LS-Series vs. LX-Series Gearbox Changes

LS40 = LX42

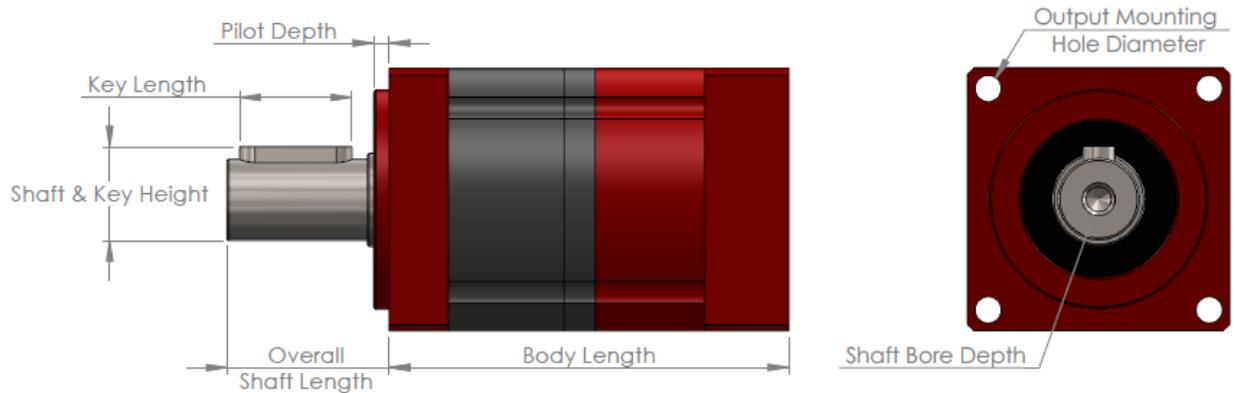
- Overall shaft length did not change
 - Pilot depth decreased by 3mm to 2.5mm
 - Shaft increased by 3mm to 23.5mm
- Key length increased by 3mm to 18mm
- Increased from 4mm to 5mm key
- Shaft & key height decreased by 0.5mm to 15mm
- Shaft bore depth increased to 10mm
- Output mounting holes increased to 4.2mm diameter
- Single stage body length increased to 64mm
- Double stage body length increased to 87.5mm

- Overall shaft length decreased by 5mm to 32mm
 - Pilot depth is now 3mm
- Single stage body length increased to 79mm
- Double stage body length increased to 106mm

- Overall shaft length decreased by 7mm to 41mm
 - Pilot depth is now 3mm
- Shaft & key height decreased by 0.5mm to 24mm
- Single stage body length increased to 99mm
- Double stage body length increased to 133.5mm
